SECTION 009113 - ADDENDA

PART 1 - Addendum #1

- A. Project Name: Maintenance Parking Lot Reconstruction Project
- B. Owner: Western Wyoming Community College
- C. Engineer: Brandt D. Lyman, PE, Western-EGI
- D. Engineer Project Number: 25-1015
- E. Date of Addendum: 04/15/2026

IMPROVEMENT PLAN NORTH
MAINTENANCE PARKING LOT
WWCC

C2.2

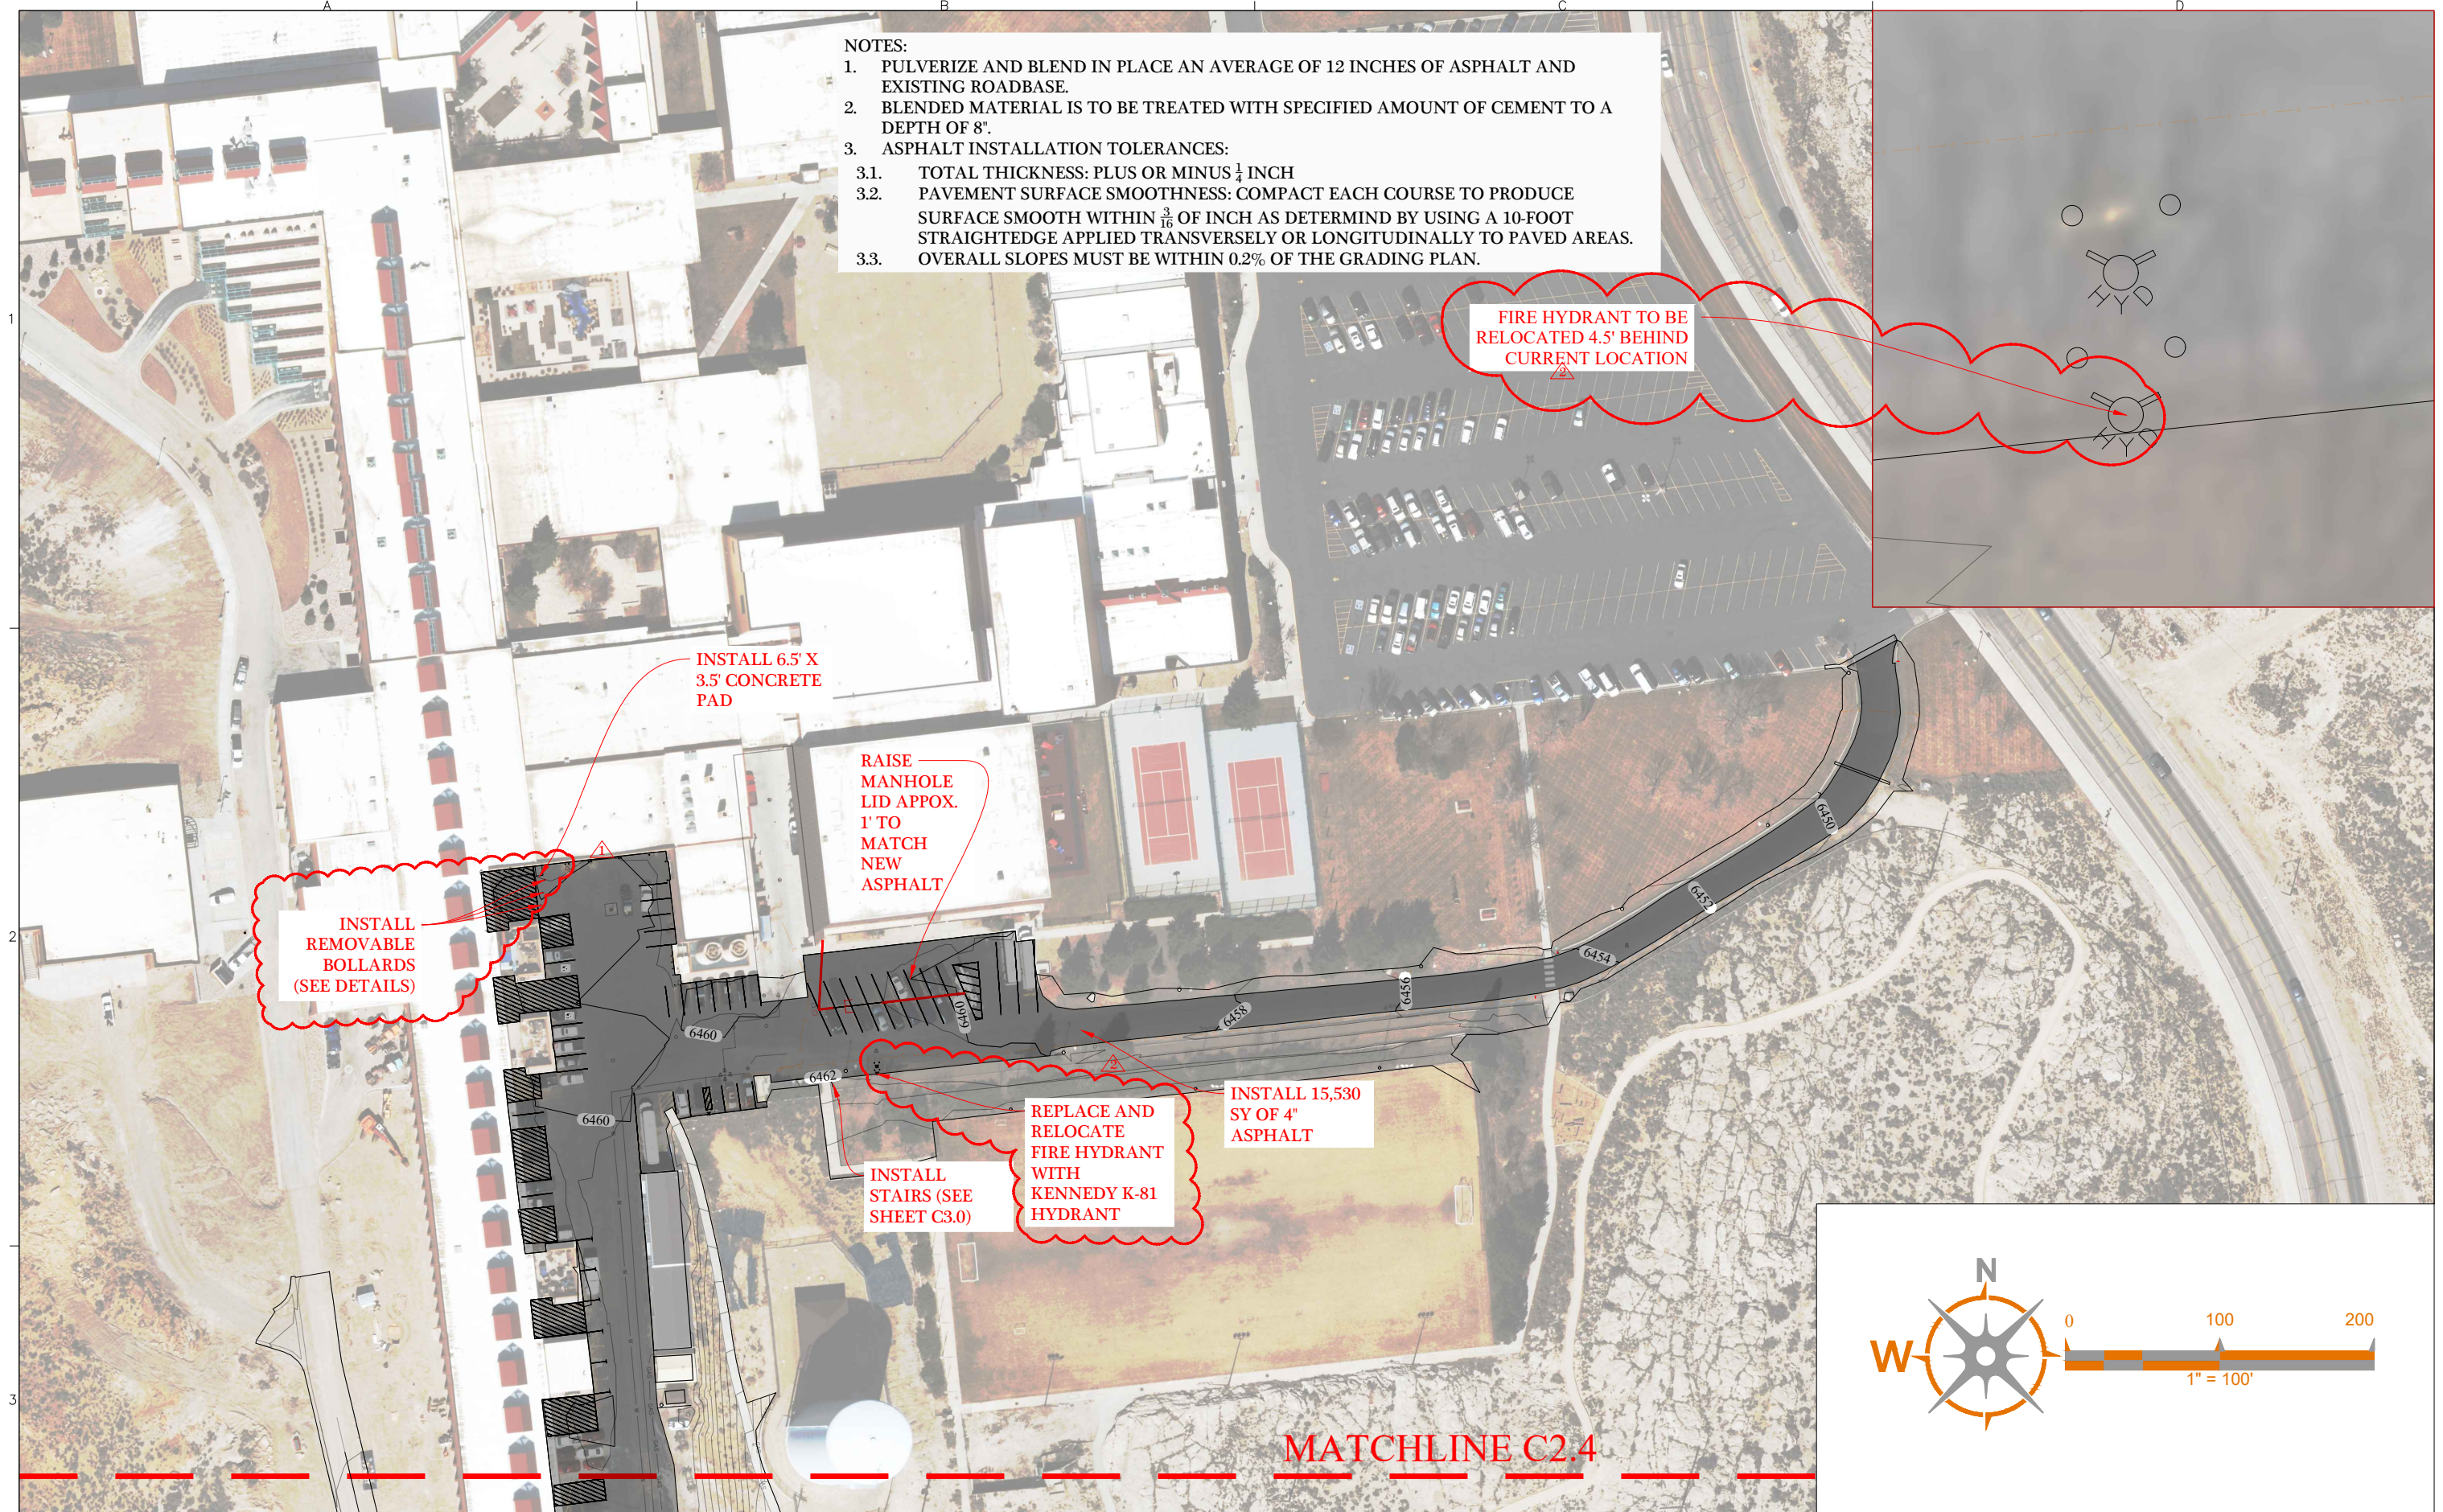
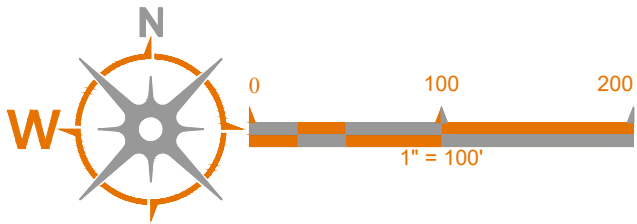
FIRE HYDRANT TO BE
RELOCATED 4.5' BEHIND
CURRENT LOCATION

INSTALL
REMOVABLE
BOLLARDS
(SEE DETAILS)

REPLACE AND
RELOCATE
FIRE HYDRANT
WITH
KENNEDY K-81
HYDRANT

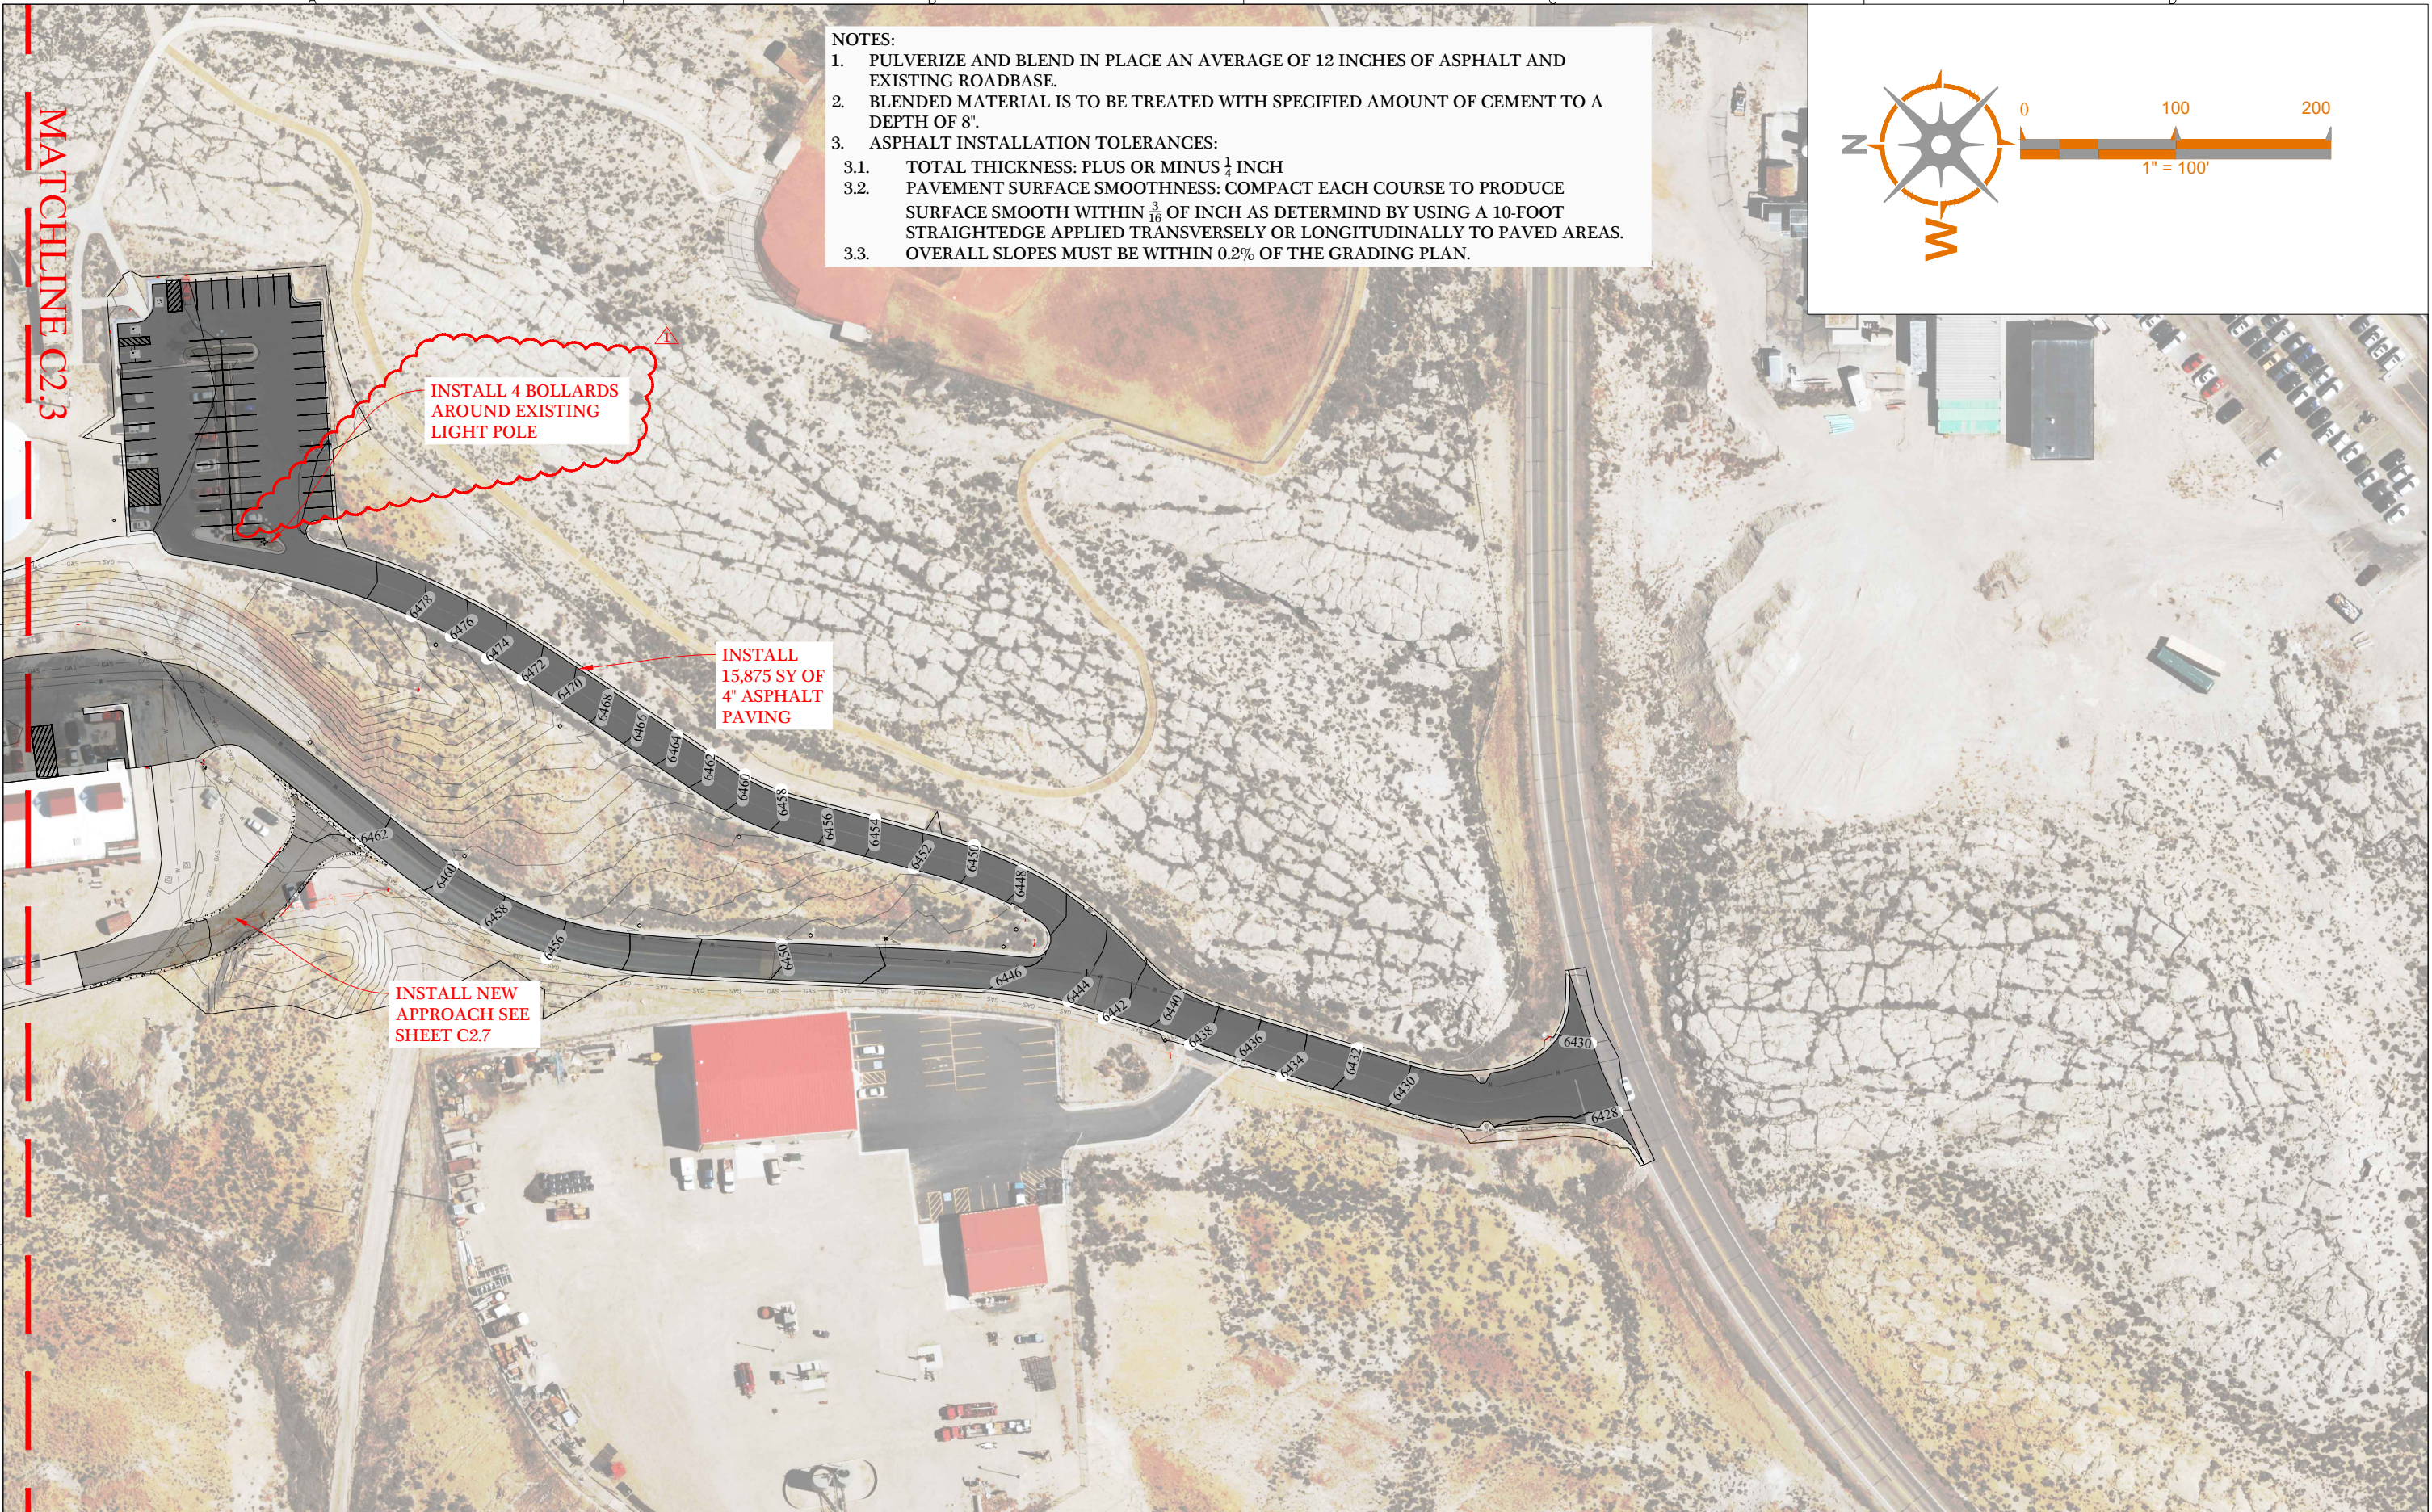
Layout: IMPROVEMENT PLAN SOUTH Plot Date: 4/15/2026 11:25:08 AM Plotted By: JasonD		 PO BOX 1478 415 N STREET ROCK SPRINGS, WY 82901 307-362-5180 WESTERN@WESTERNEGI.COM WWW.WESTERNEGI.COM	No.	Revision Comment	IMPROVEMENT PLAN SOUTH MAINTENANCE PARKING LOT WWCC	Job No.: 25-1015	C2.3
In no event shall the Client copy or use any of the concepts, plans, drawings, specifications, designs, models, reports, photographs, computer software, surveys, calculations, construction and other data, documents, and processes produced by the Engineer in connection with the Project (the "Instruments of Service") for any purpose other than those noted above or in relation to any project other than the Project without the prior written permission of the Engineer. The Engineer shall not unreasonably withhold or deny such consent but shall be entitled to receive additional equitable remuneration in connection with its grant of consent. Path: Q:\Projects\2025 Projects\25-1015 WWCC Maintenance Parking Lot Reconstruction\DWG\Maint Parking Lot_2-11.dwg				INSTALL FOUR BOLLARDS AROUND LIGHT POLE		Date: 4/15/26

CONCRETE FILLED BOLLARD
1"=1'

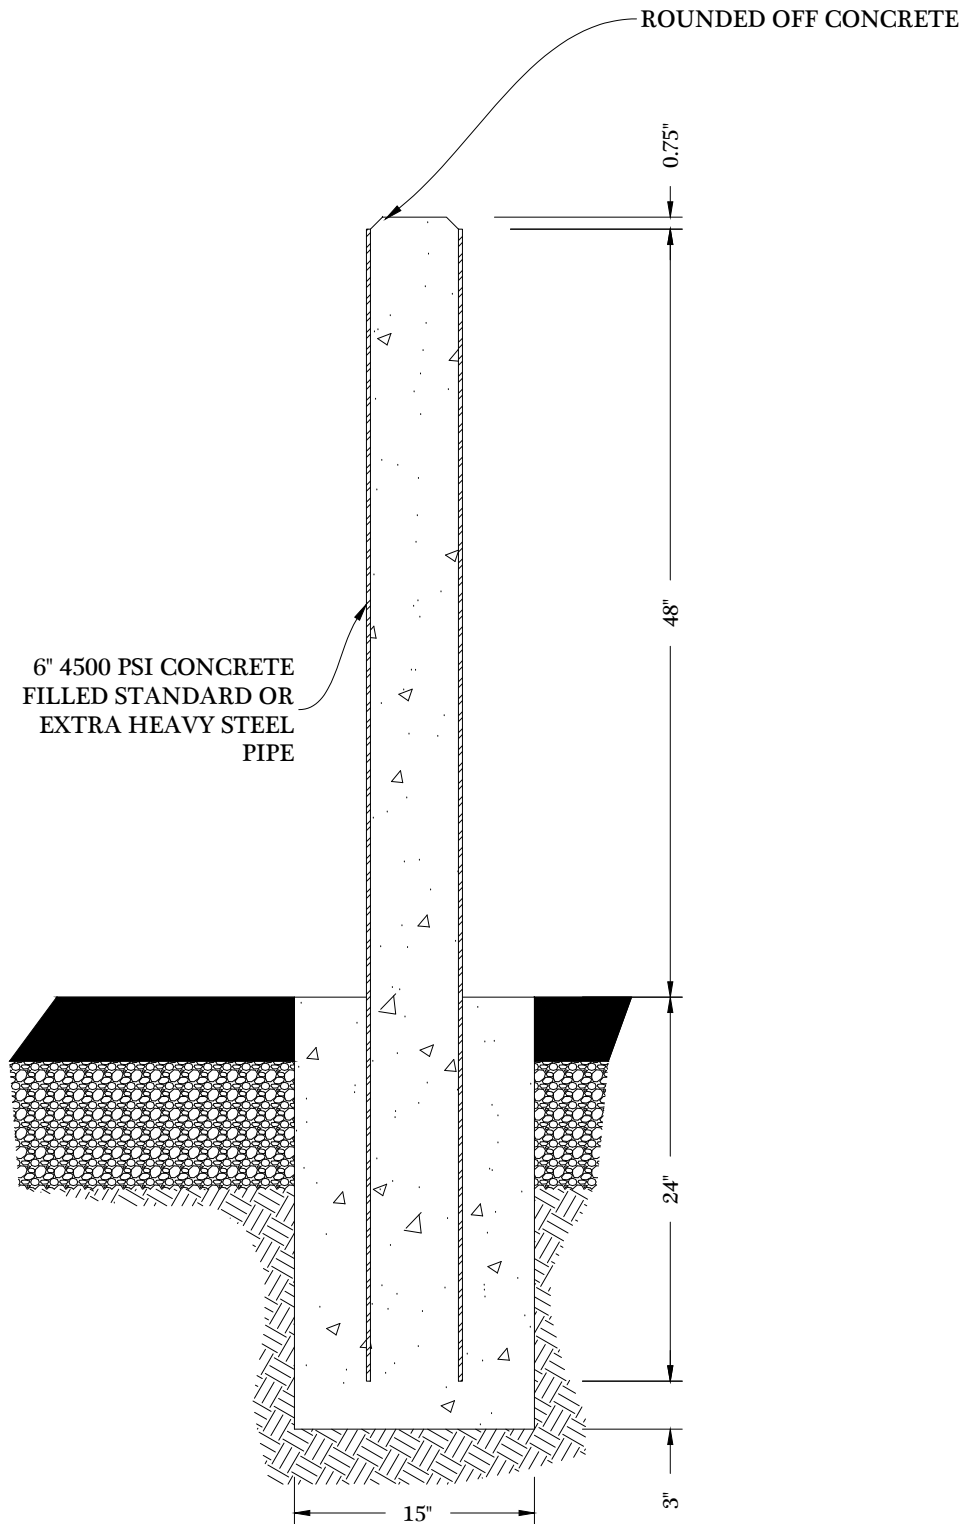
- A. This Addendum includes 4 attachments.
- B. This Addendum includes the following attached Documents and Specification Sections:
 - 1. Plans have been updated to include bollard detail and location and fire hydrant relocation and detail and curb cuts on new approach
